Product Service Bulletin

All 2.50" Tandem Side-Door Stripper/Packers
Reference Tech Units 1170, 1207, 1223 and 1233.

PSB-035

EXISTING ARRANGEMENT

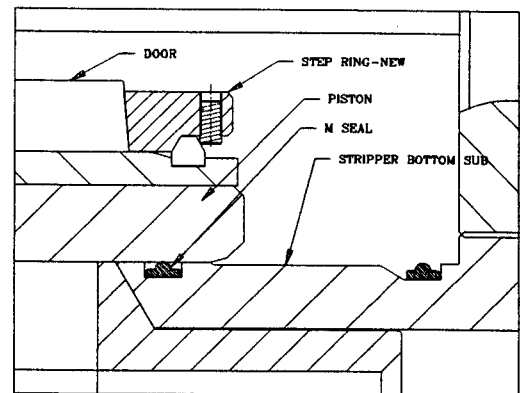
It has come to Texas Oil Tool's attention that there is a fault with 2.50" Tandem Side-Door Stripper/Packers; namely that the main 'M' seal in the bottom sub can extrude at higher pressures. This condition only occurs when the piston is being pressurised to retract, but with the doors closed, eg, when pressure testing the upper stripper.

The remedy for this potential occurrence is to change out the existing step ring (part number 9101-2926) with a new, longer ring (part number 9628-2120), see sketch below for details of change.
